Early Site Permit (ESP) Application for the Clinton ESP Site
Docket No. 52-007

Subject: Response to Draft Safety Evaluation Report (DSER) Items

- Re: 1) Letter, U.S. Nuclear Regulatory Commission (W. D. Beckner) to Exelon Generation Company, LLC, (M. Kray), dated February 10, 2005, Draft Safety Evaluation Report for the Exelon Early Site Permit Application
- 2) Letter, Exelon Generation Company, LLC (M. Kray), to U.S. Nuclear Regulatory Commission dated April 4, 2005, Partial Response to Draft Safety Evaluation Report (DSER) Items

**DECATUR, ILLINOIS AND MADISON, WISCONSIN
MAXIMUM NET ACCUMULATED FREEZING DEGREE DAYS
WINTERS 1896-2003**

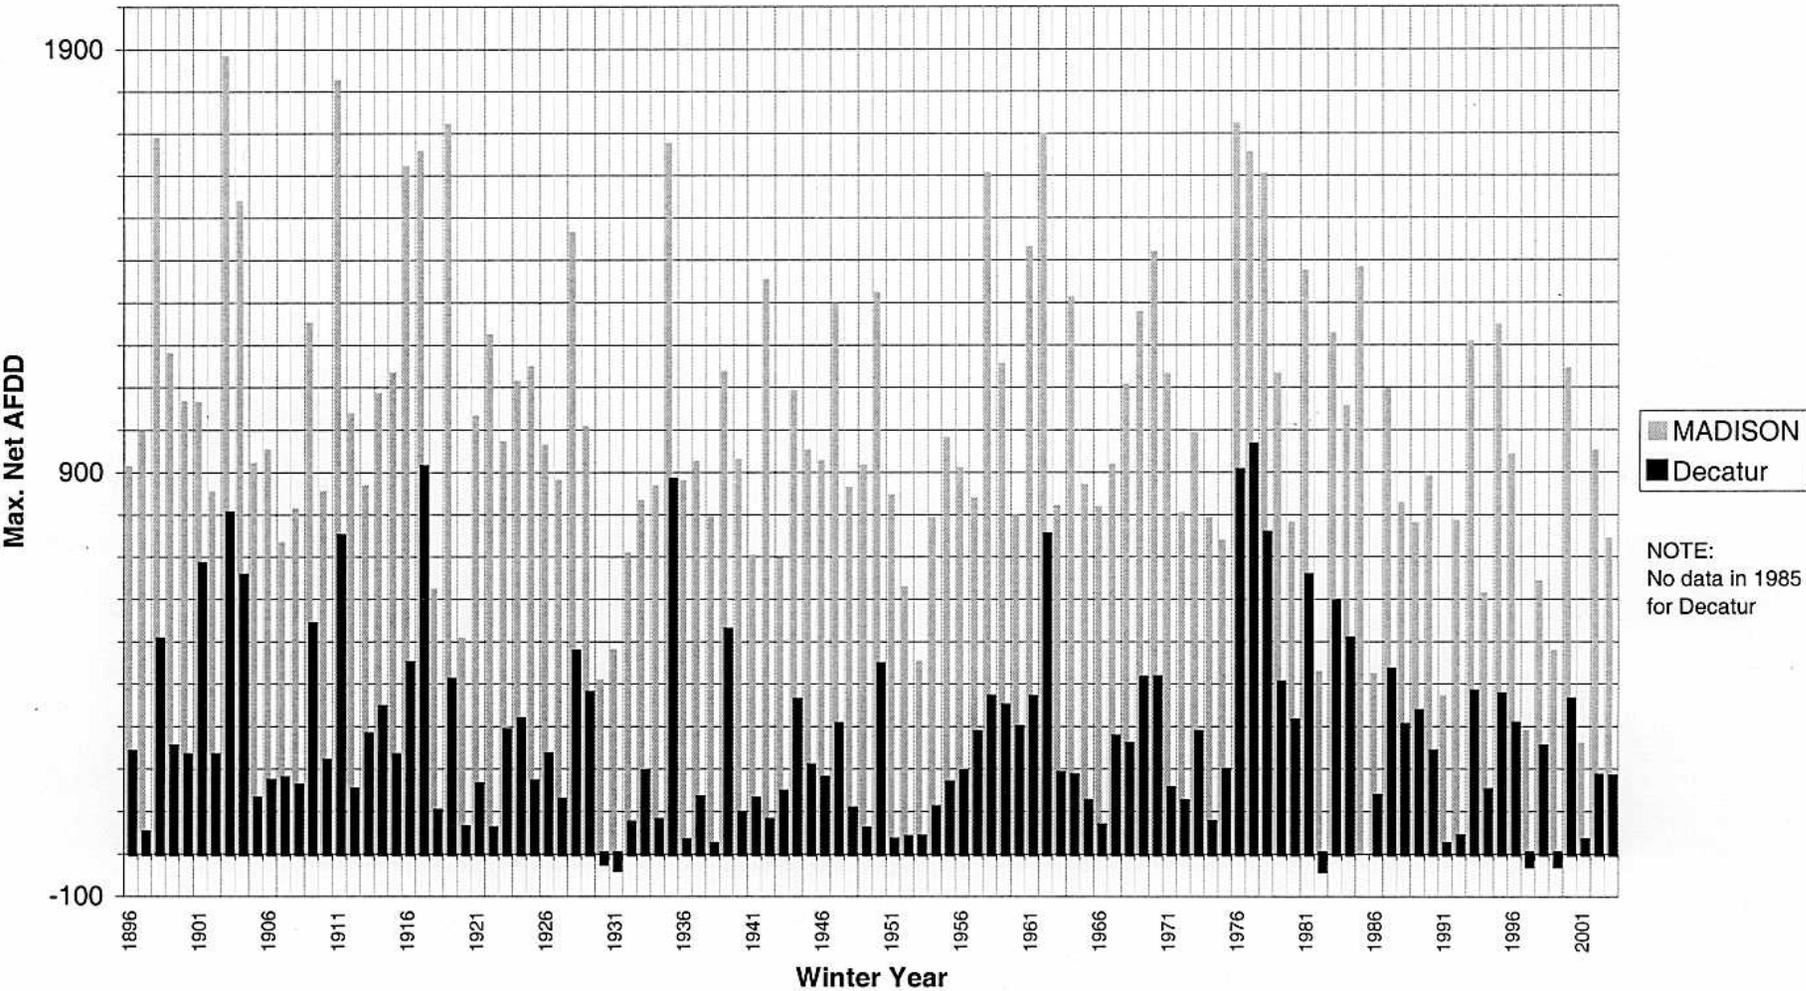
up on December 1st. This suggests that Method 1, which establishes the initial date of ice freezing based on FDD, would provide a more accurate estimate of ice thickness

Based on the results of the ice thickness evaluation and the discussion above, it is recommended that the maximum ice thickness be established based on the USACOE 2002 equation and the calculated date of initial ice freeze up using Monona Lake FDDs as a conservative indicator of initial ice freeze up. It is further recommended that the worst case value of ice thickness over the 108-years of record be used as the design value for the ESP safety analysis report. This value is 24.8 inches and is within the bounding limits for a 95 percent confidence interval for the 50-year return period.
